### Architectural Review Board Staff Report October 13, 2025 Meeting

### CERTIFICATE OF APPROPRIATENESS NEW ALBANY POLICE STATION BUILDING ADDITION

STRATEGIC PLAN: Village Center APPLICATION: ARB-66-2025

> **EXTERIOR ELEVATIONS**

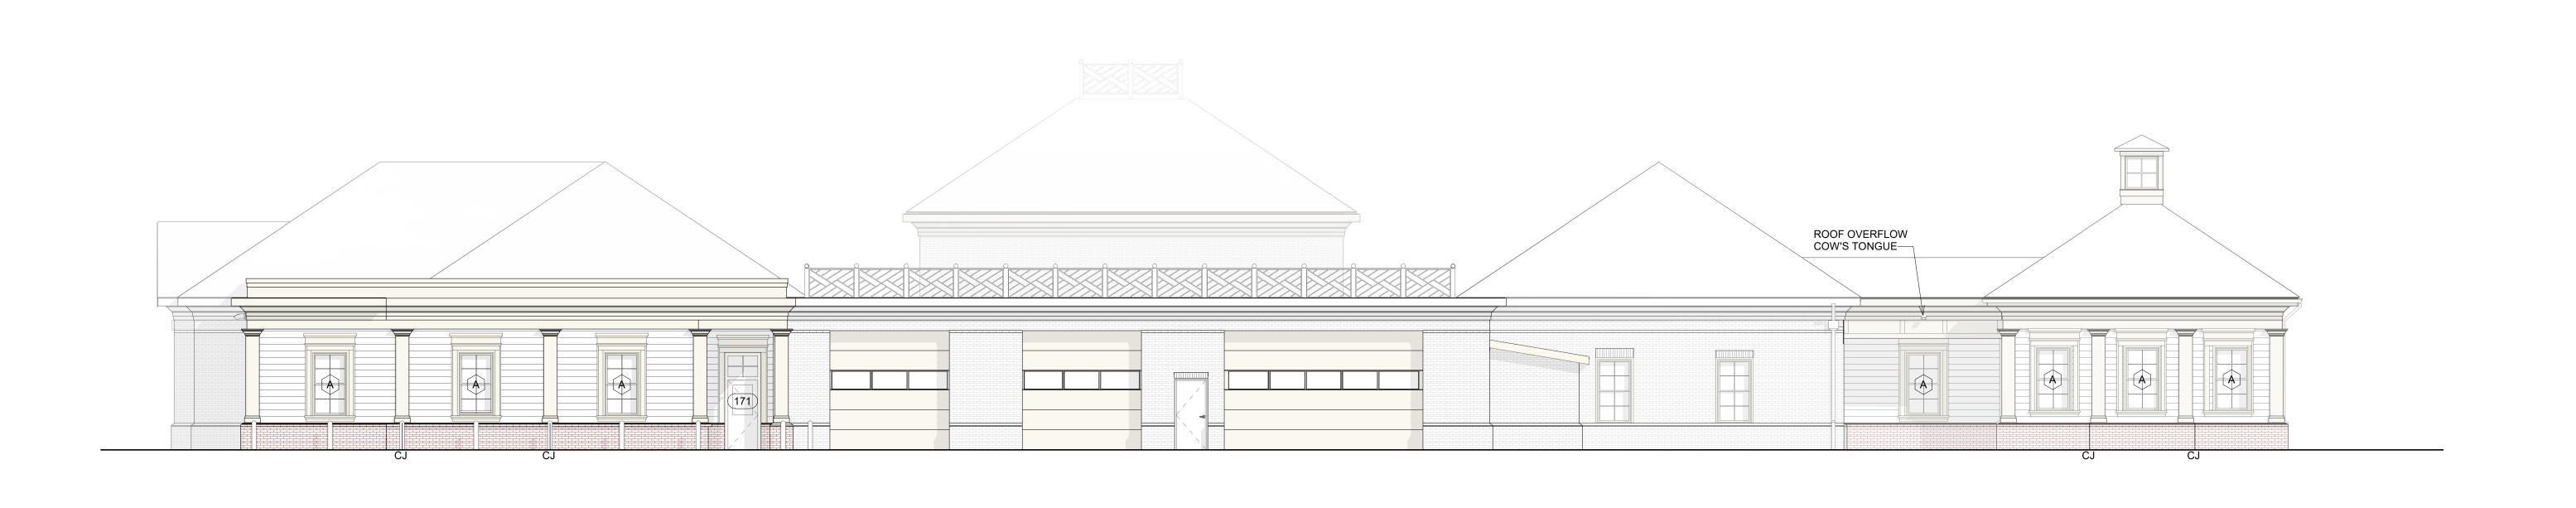
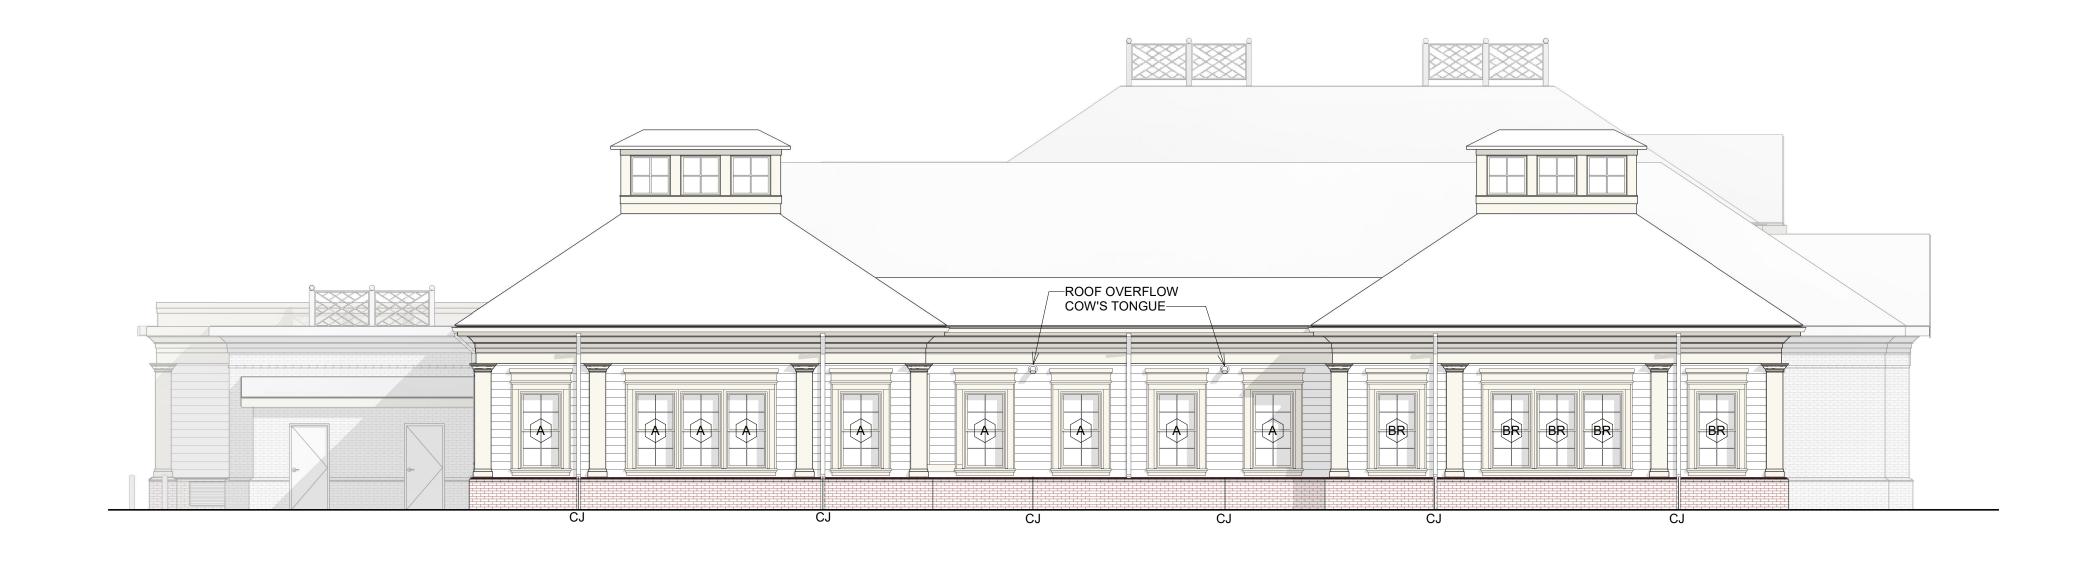
- O The city architect reviewed the proposal and is supportive of the overall design. Composite siding (Hardie material) is used on the walls of the addition above the brick base. Even though painted siding isn't found on the existing building, it is historically considered a complementary exterior material to brick when used on a secondary form, according to the city architect. The use of siding on the addition, in this case, preserves the architectural integrity of the existing building. If the brick were to clad the entirety of the new work, it would compete with the existing main form, throwing off the overall composition.

- The city architect reviewed the proposal and stated that historically, when new work is added to an existing substantially scaled building, it benefits the

architecture to preserve the integrity of the primary building mass. The proposed design achieves this DGR requirement by hierarchically treating the addition as a dependency/second in nature with its shape and proportions.

- The applicant identifies the following exterior materials on the proposed plans:
  - o Composite siding (painted)
  - o Brick water table (match existing)
  - o Face brick (match existing)
  - Asphalt roof shingles
  - Window trim (painted)
  - o Fypon crown (match existing)
  - Engaged column (painted)
- 2. The visual and functional components of the building and its site, including but not limited to landscape design and plant materials, lighting, vehicular and pedestrian circulation, and signage.
